IEEE P802.15 Wireless Personal Area Networks

Project	IEEE P802.15 Working Group for Wireless Personal Area Networks (WPANs)	
Title	TG3 SB1 comment resolution	
Date Submitted	[6 February, 2003]	
Source	[James P. K. Gilb] [Apparent Technologies] [15373 Innovation Drive, #210, San Diego, CA 92129]	Voice: [858-485-6401] Fax: [858-485-6406] E-mail: [gilb@ieee.org]
Re:	[]	
Abstract	[This document is a record of comment resolutions for SB1.]	
Purpose	[To provide a record of the comment resolution for SB1.]	
Notice	This document has been prepared to assist the IEEE P802.15. It is offered as a basis for discussion and is not binding on the contributing individual(s) or organization(s). The material in this document is subject to change in form and content after further study. The contributor(s) reserve(s) the right to add, amend or withdraw material contained herein.	
Release	The contributor acknowledges and accepts that this contribution becomes the property of IEEE and may be made publicly available by P802.15.

Figure 6—MSC for acquiring DEV IEs using the Probe Request command.

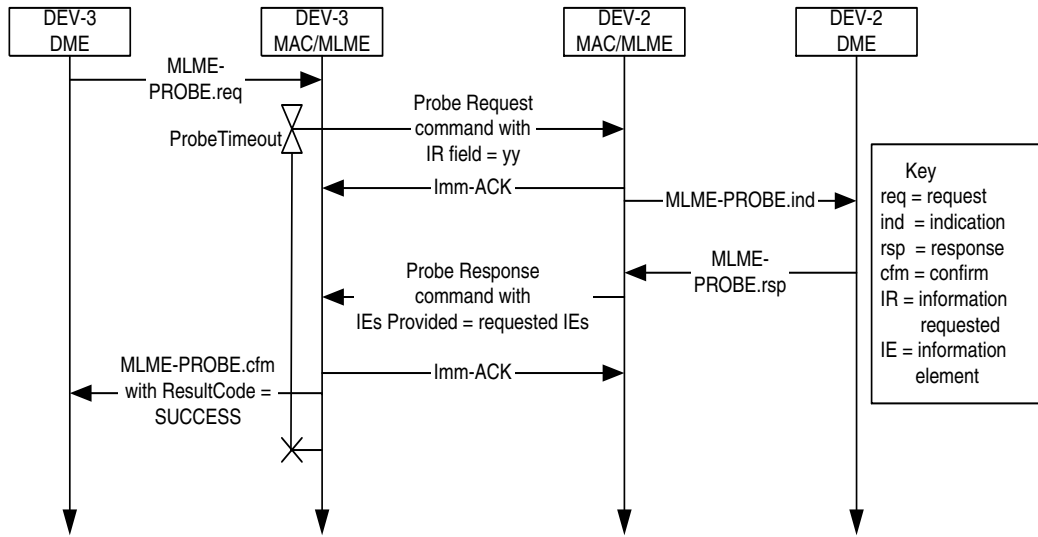
Figure 6 illustrates the sequence of messages involved in acquiring DEV IEs from a target DEV using the Probe Request command.

Figure 7—MSC showing sending of information using Probe command

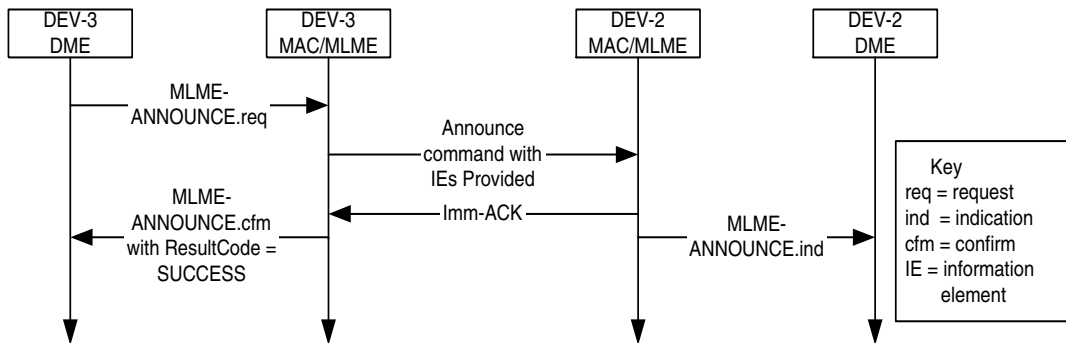
Figure 7 illustrates the sequence of messages involved in using the Announce command for sending information.

Figure 8—CTRq time unit covering multiple frames with CTRq TU MIFS = 1

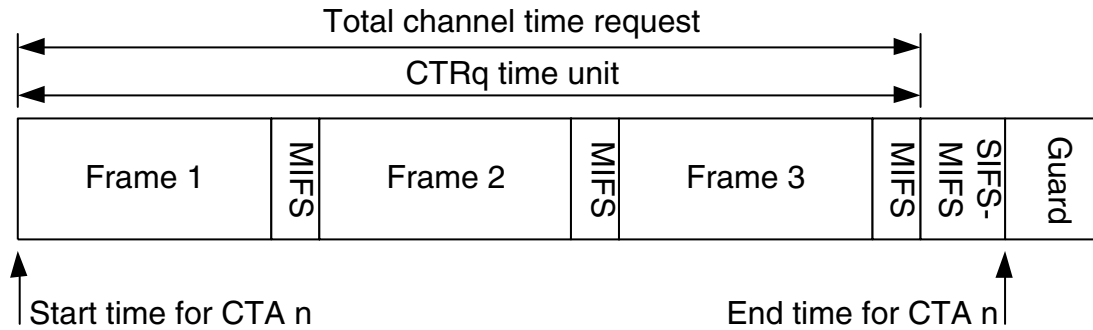
CID 682 - Needed to add one more figure, see also 03/059r0 for complete section. The new figure and text 47

Figure 8 shows a multi-frame CTRq with the CTRq TU MIFS field set to 1.

Figure 9—PNC sending the piconet services command to a newly associated DEV in response to a request in the association proces.

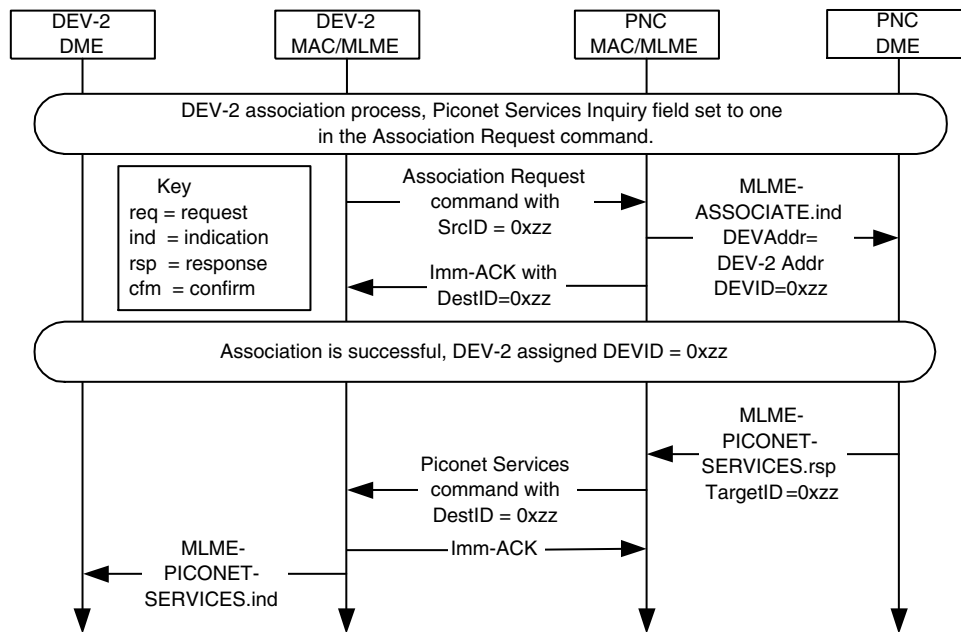
CID 299 (Sarlo, assigned to Bain) - The sentence "The association process does not wait for the piconet services command to complete." can result in problems. For example, if the association process completes before the PNC transmits the piconet services command, the newly associated dev would not receive the command because the command is addressed to the UnssocID and not the associated DEVs newly acquired DEVID. Change: "If the DEV sets the piconet services inquiry bit, the PNC shall send the piconet services

command, 7.5.4.6, with DestID set to UnassocID. The association process does not wait for the piconet services command to complete." To: "If the DEV sets the piconet services inquiry bit, the PNC shall send the piconet services command, 7.5.4.6, with DestID set to UnassocID before it allocates a DEVID to the associating DEV via the association response command." **Suggest accept in principle:** "Change: 'If the DEV sets the piconet services inquiry bit, the PNC shall send the piconet services command, 7.5.4.6, with DestID set to UnassocID. The association process does not wait for the piconet services command to complete.' To: 'If the DEV sets the piconet services inquiry bit, the PNC shall send the piconet services command, 7.5.4.6, with DestID set to UnassocID before it allocates a DEVID to the associating DEV via the association response command.' Also, add a new paragraph to 8.3.1 at line 51 on page 172. 'If the PNC is going to send the piconet services command, {xref 8.3.2}, it shall do so prior to sending the association response command.' In figure 103, insert a message after MLME-ASSOCIATE.rsp and before association response command. This message is in the direction of PNC MLME to DEV-2 MLME . 'Piconet services command with DestID=UnassocID (note: this command is only sent if PNC is to provide this command)'. There is no ack."

Accept in principle "Change to 'If the DEV sets the piconet services inquiry bit, the PNC shall send the piconet services command, 7.5.4.6, with DestID set to newly assigned DEVID after that PNC has received the second Association Request command from the DEV, {xref }. This process is illustrated in {figure xx}.' and add new MSC as shown in 03/032r10."

Figure 11—MSC for the handing over control of a private, pseudo-static CTA

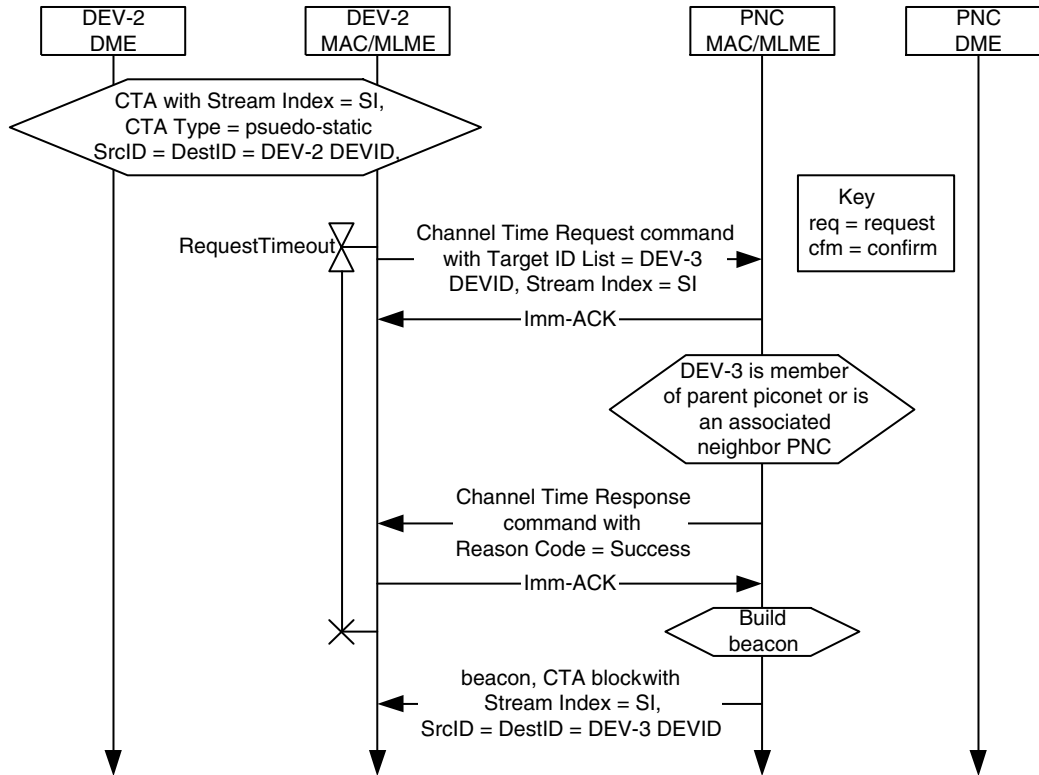
The MSC for the handover of the control of a private, pseudo-static CTA is illustrated in Figure 11.

Resolve CIDs 1, 215, 352 and 139 as Accept in principle “Add the ability to handover the dependent PNC as indicated in 03/032r8.”

Figure 12—Successful PNC handover in a dependent piconet.

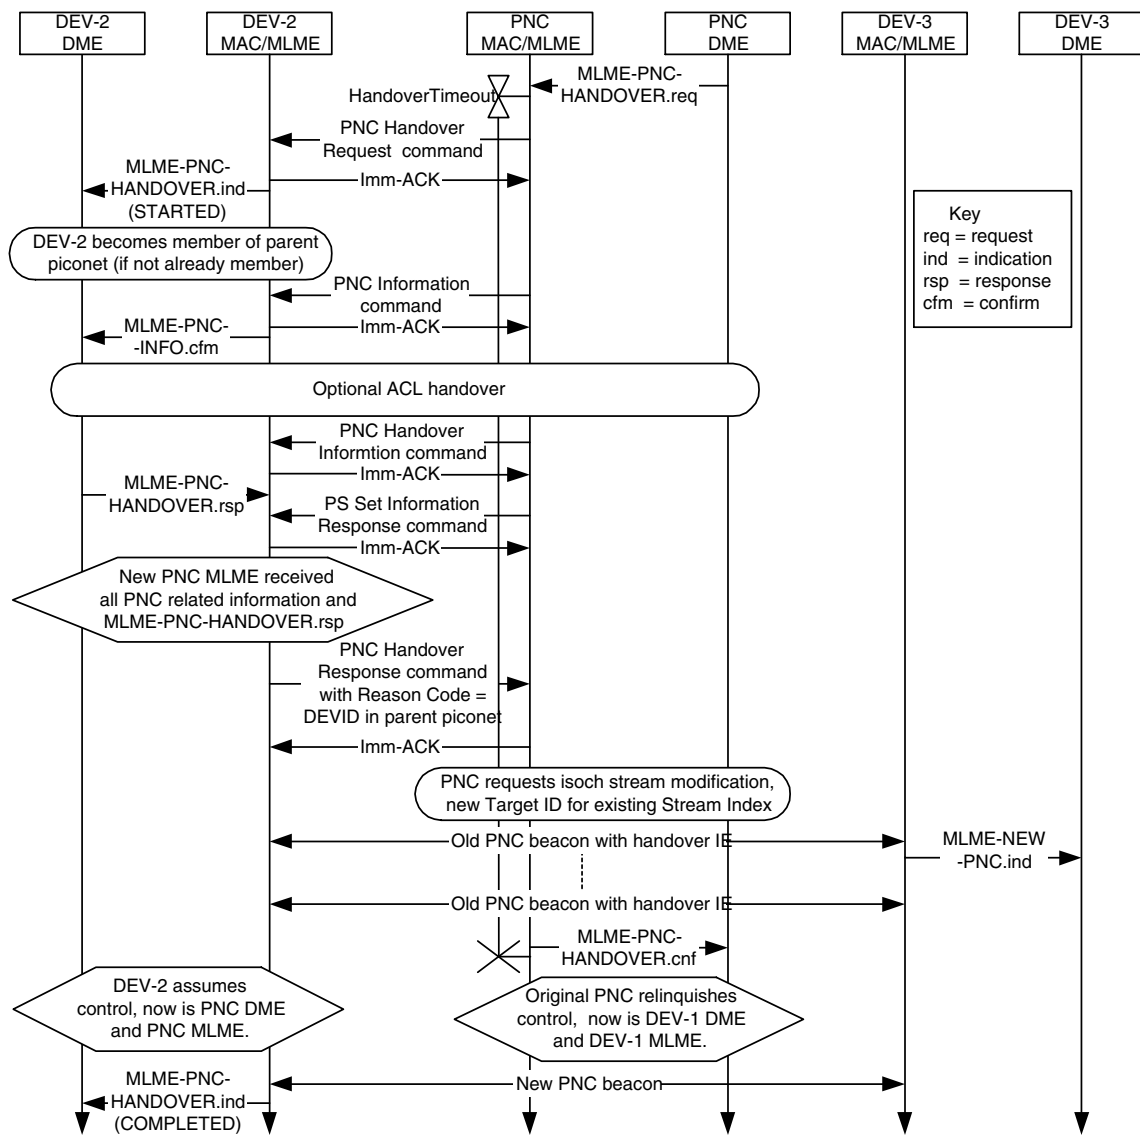
The dependent PNC handover process begins in the same manner as a regular PNC handover, {xref 8.2.3}, with the current PNC sending the PNC Handover Request Command to the target DEV that it has selected to

become the new PNC, as shown in Figure 12. In this and the two subsequent figures, the identities PNC, DEV-2 and DEV-3 are all relative to the dependent piconet and not the parent piconet. If the target DEV is not a member of the parent piconet, then that DEV shall begin the association process to join the parent piconet and, if required, authenticate with the parent PNC. The target DEV may request to associate with the parent piconet as either a neighbor PNC or as a member of the piconet. While target DEV is attempting to join the parent piconet, the current dependent PNC shall send the target DEV the information about all of the DEVs with the PNC Information command, all of the current channel time requests with the PNC Handover Information command and the power save information, if any, using the PS Set Information Response command. The target DEV may also request the transfer of any ACL data at this point using the ACL Information Request command. Note that the transfer of this information will not interfere with the target DEV's association and authentication process because the former occurs only during time reserved for the dependent piconet while the latter only occurs during time reserved for the parent piconet.

Figure 13—Failed dependent PNC handover when target DEV fails to join parent piconet.

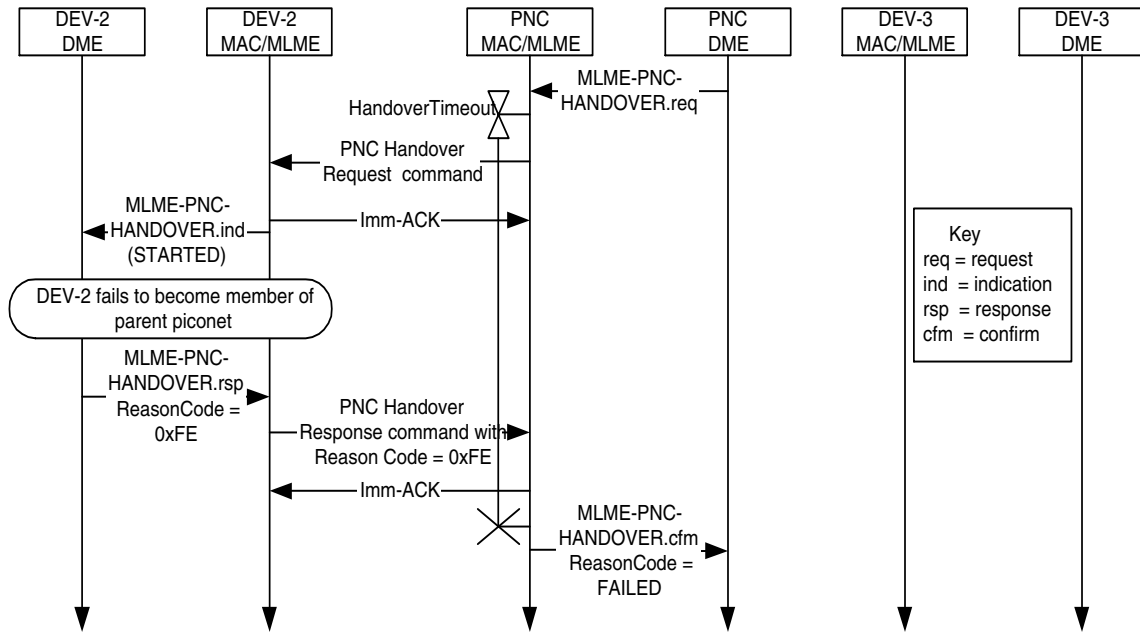
If the target DEV fails to join the parent piconet as either a regular DEV or as a neighbor PNC, it shall send the PNC Handover Response command to the dependent PNC with the Reason Code set to 'Handover

refused, unable to join parent piconet' as illustrated in Figure 13. The target DEV may refuse the handover at any time while the dependent PNC is sending over the information about the piconet.

Figure 14—Failed dependent PNC handover when control for the dependent piconet CTA is handed over in the parent piconet.

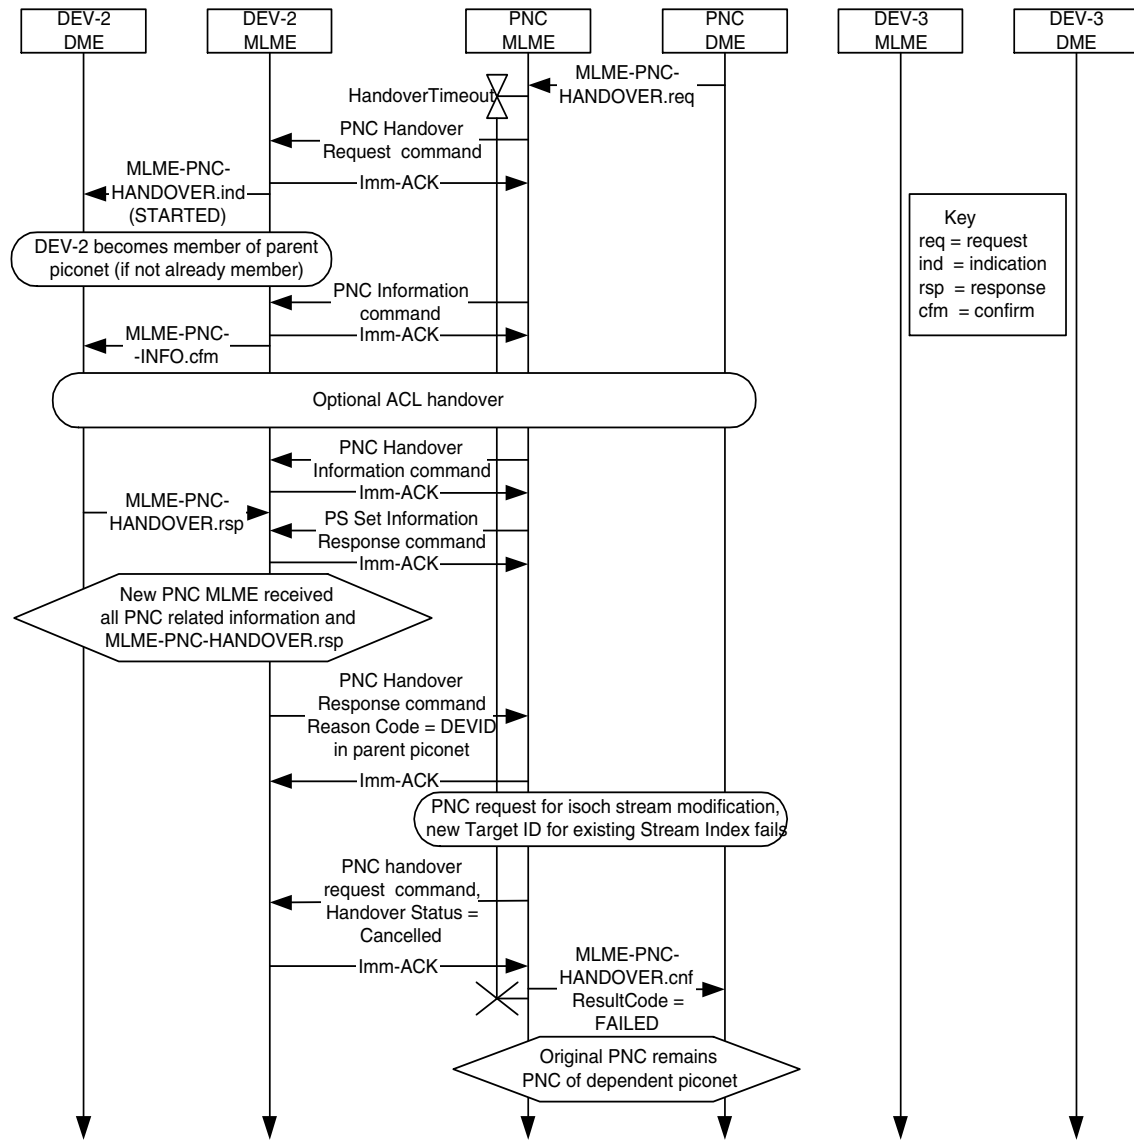
If the parent PNC rejects the request to handover control of the CTA to the new dependent PNC, the dependent PNC shall send a PNC Handover Request command to the target DEV with the Handover Status field set to 1 to indicate that the handover process is being cancelled, as illustrated in Figure 14.

Figure 15—Channel time request for frames with immediate ACKs

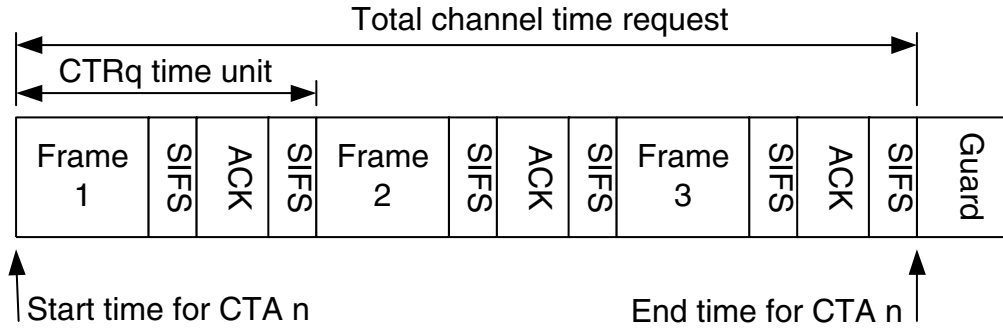
CID 682: - **Suggest accept in principle:** The inclusion of MIFS changed the CTR calculations, but the changes were not reflected in 8.4.4.6. '1)Change b3 in Figure 79 from "stream termination" to "MIFS CTRq TU". 2)Replace page 152, line 12 with:

The requesting DEV shall include the frame transmission time, if known *a priori*, and the ACK transmission time, if used, and MIFS or SIFS time as appropriate per frame or ACK when calculating channel time

requests. Figure 15 (was #108) shows an example of channel time being requested for a CTA where Imm-ACKs are used.

Figure 16—Channel time request with no ACKs

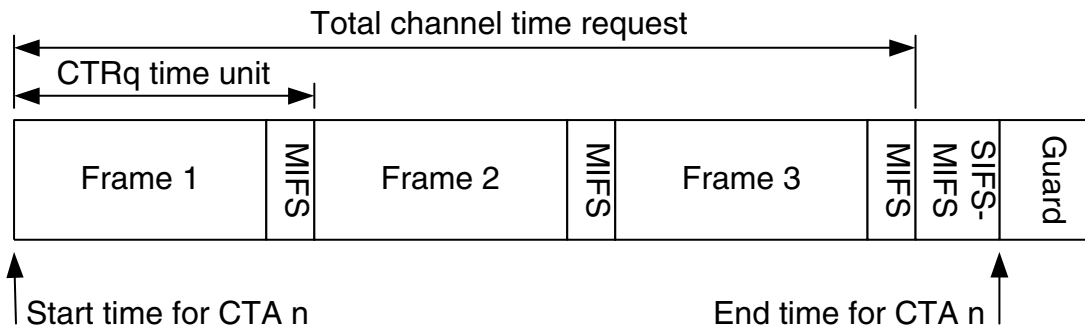
When No-ACK is used, the channel time request is calculated differently because there is a MIFS in between each frame in the CTA instead of a SIFS. A channel time request that uses a CTRq TU with MIFS instead of SIFS shall set the CTRq TU MIFS bit to one to inform the PNC that it must add a time equal to SIFS-MIFS to the end of the CTA. This ensures that there is a SIFS between the end of transmission in one CTA and the start of the next. Figure 16 shows an example of a channel time request when no-ACK is used and the MIFS bit is set in the Channel Time Request command.

Figure 17—CTRq time unit covering multiple frames with no-ACK policy

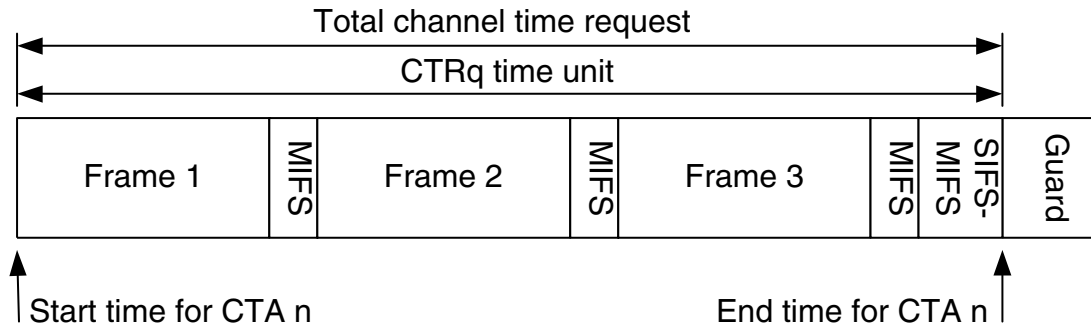
A CTRq TU in the CTA may cover more than one frame as shown in Figure 17. If the requesting DEV included SIFS-MIFS following the last MIFS as shown in Figure 17 it shall set the CTRq TU MIFS in the

Channel Time Request to "0." IF SIFS-MIFS is not included in the CTRq TU, the CTRq TU MIFS bit shall be set to "1" and the PNC shall add SIFS-MIFS to the CTRq TU to calculate the duration of the CTA.
